Hi-Fi Products
Service Bulletin

Model: TA-F210

No. 133

Subject: Loudness Effect Not Sufficient

[FUNCTION BOARD]

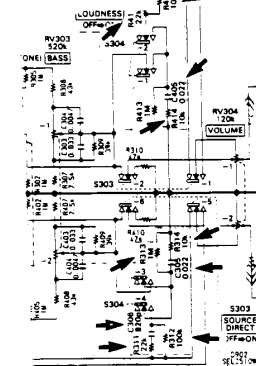
If the loudness effect is not sufficient when the loudness button is pressed, replace the following parts.

| Ref. No. | Description | | Part Number |
|------------|------------------------|------------------------|--------------|
| R311, R411 | Resistor, 22k 1/4W | Resistor, 10k 1/4W | 1-247-725-11 |
| R312, R412 | Resistor, 100k 1/4W | Resistor, 27k 1/4W | 1-249-463-11 |
| R314, R414 | Resistor, 10k 1/4W | Resistor, 4.3k 1/4W | 1-247-846-11 |
| C306, C406 | Capacitor, 820pF | Capacitor, 1200pF | 1-164-086-11 |
| C305, C405 | Capacitor, 0.022uF | Capacitor, 0.047uF | 1-136-161-00 |
